**ADDENDUM NO. 03
September 26, 2022**

**WINDSONG ELEMENTARY SCHOOL ADDITION & RENOVATION ISSUE FOUR PROPOSAL
FOR FRIENDSWOOD I.S.D.**

Prepared by: PBK
11 Greenway Plaza, 22nd Floor
Houston, TX 77046-1104
PBK Project No: 20380

13 1ST LEVEL - CEILING PLAN - AREA F ALTERNATE NO. 03
1/8" = 1'-0"

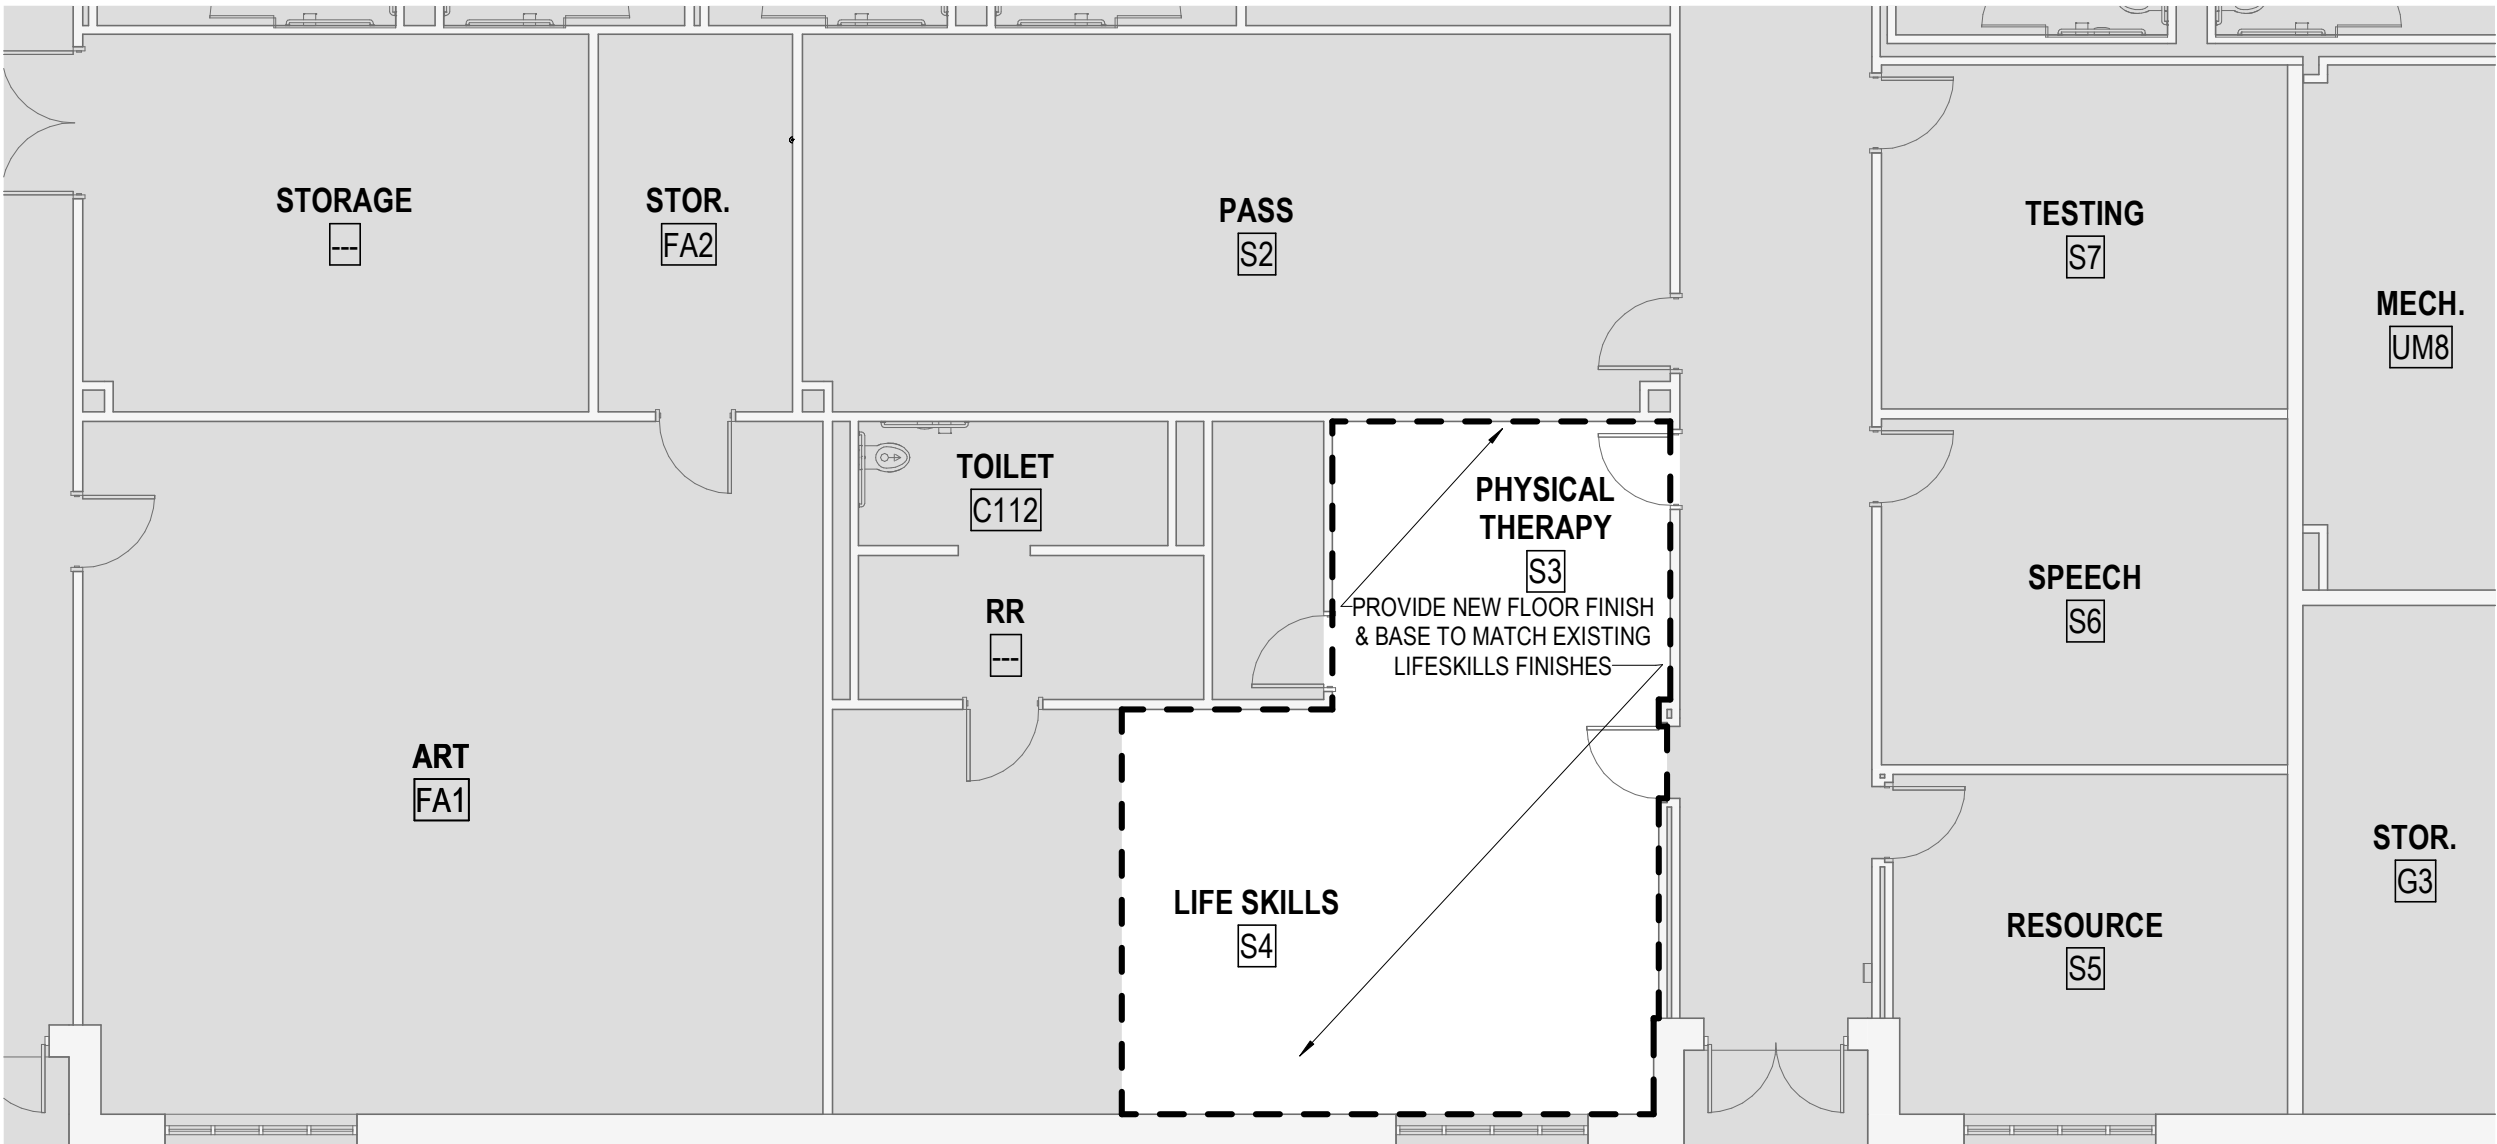
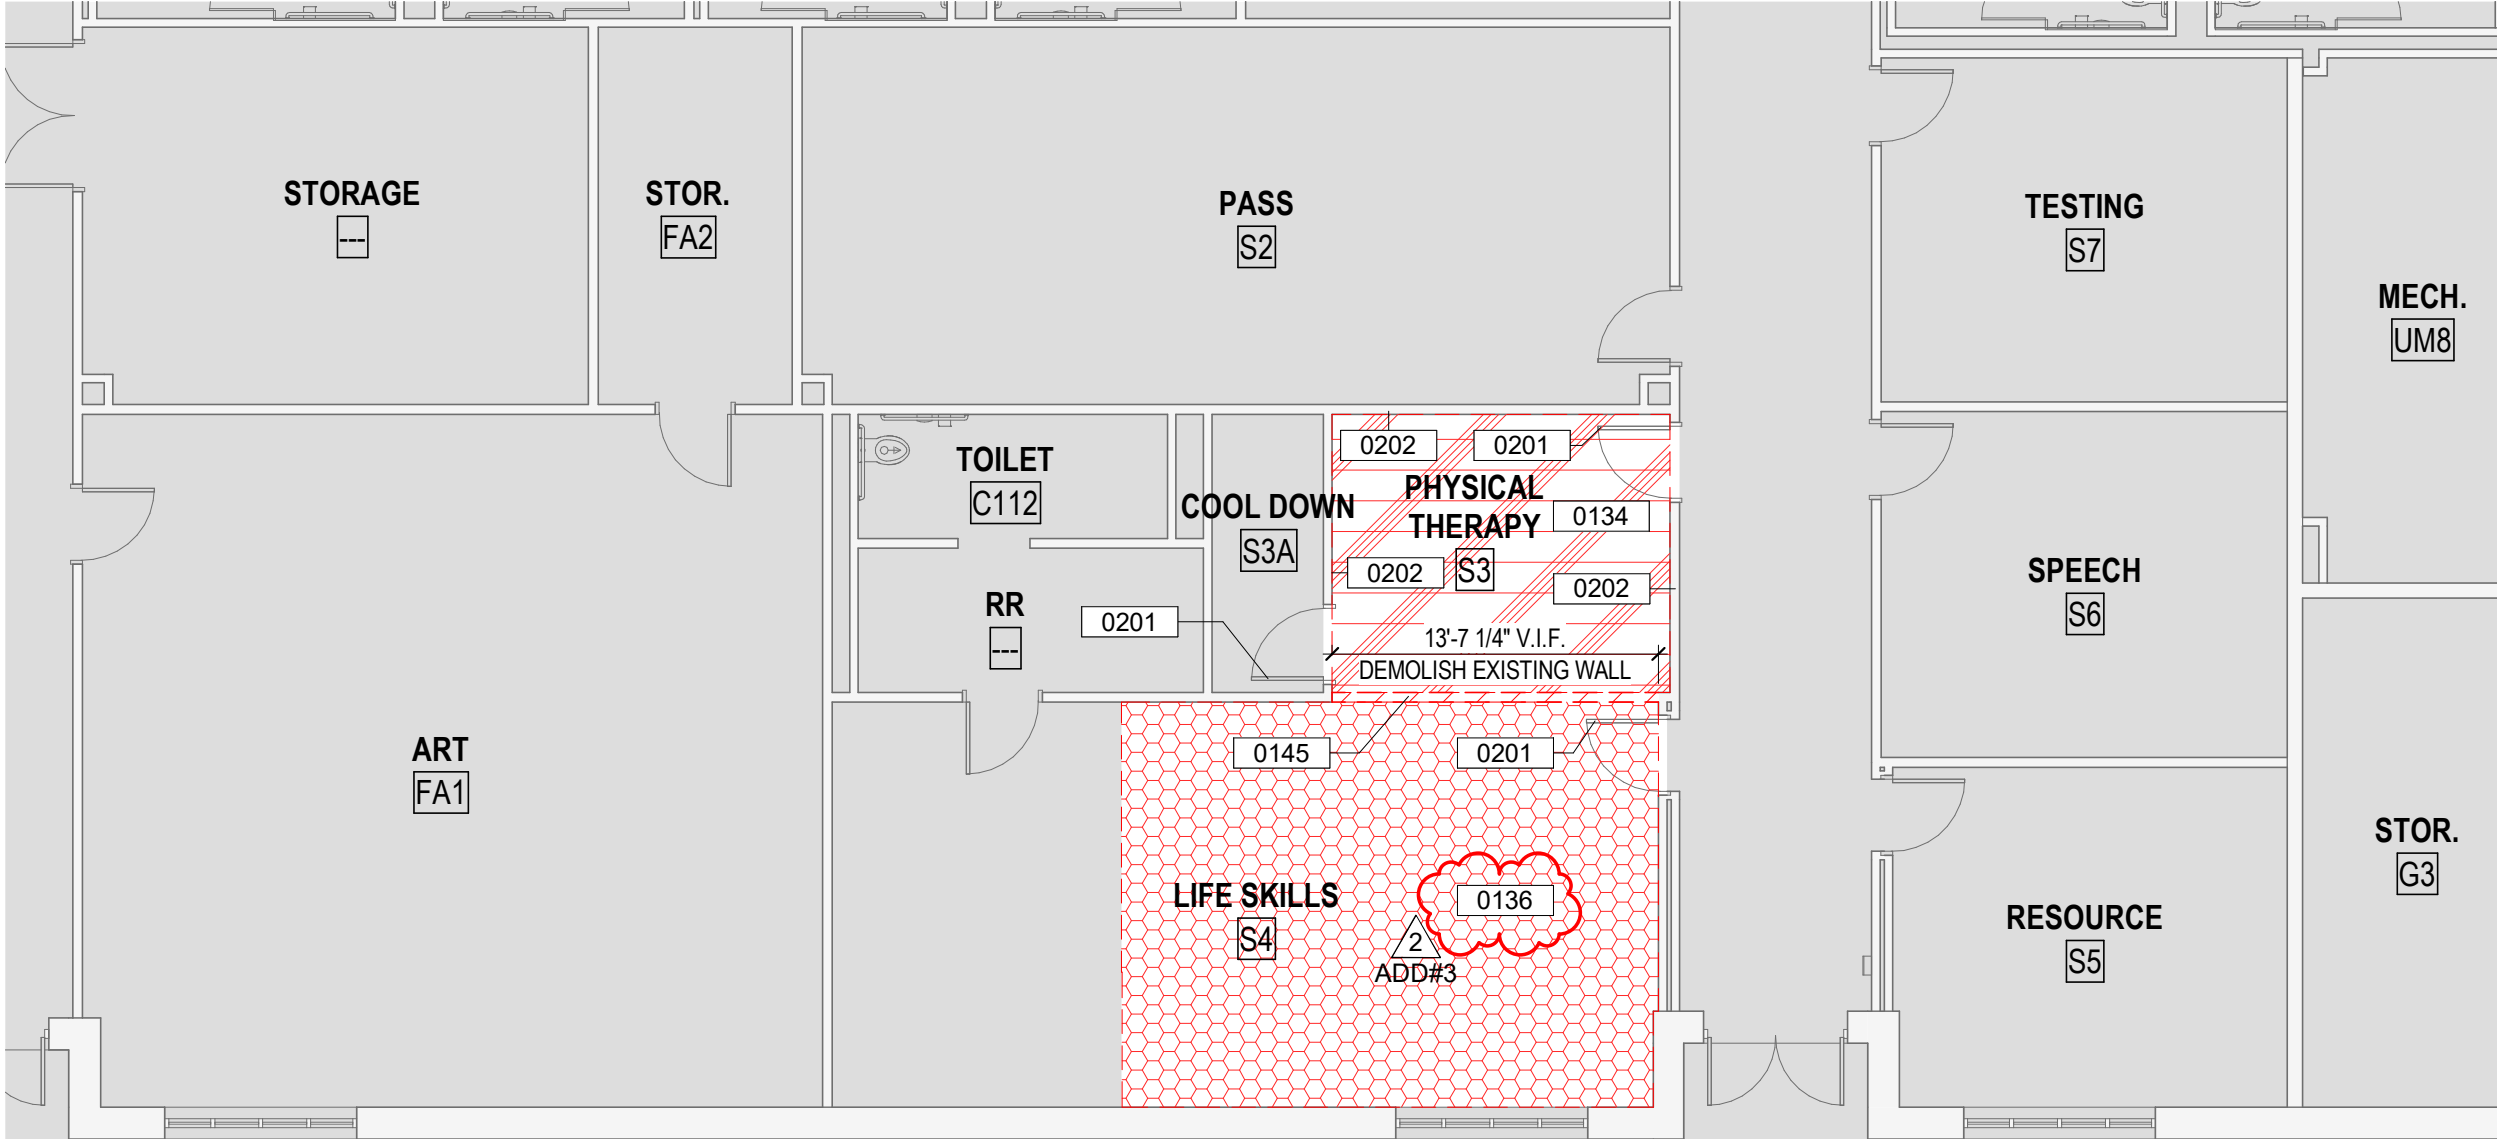
A. Revised ceiling plan to have Furdown, refer to attachment.
 B. Removed Cool Down room from room finish schedule, refer to attachment.
 C. Removed keynote 0134 from Life Skills and added keynote 0136, refer to attachment.

D. Revise carpet in rooms S3 and S4 to CPT-1.
- Item No. 60 **A-101G1 1ST Floor Plan – Area G – Schedules**
 A. Revised east and east and west walls of Multipurpose to read "VWC-1/WRITABLE SURFACE" on the room finish schedule, refer to attachment.
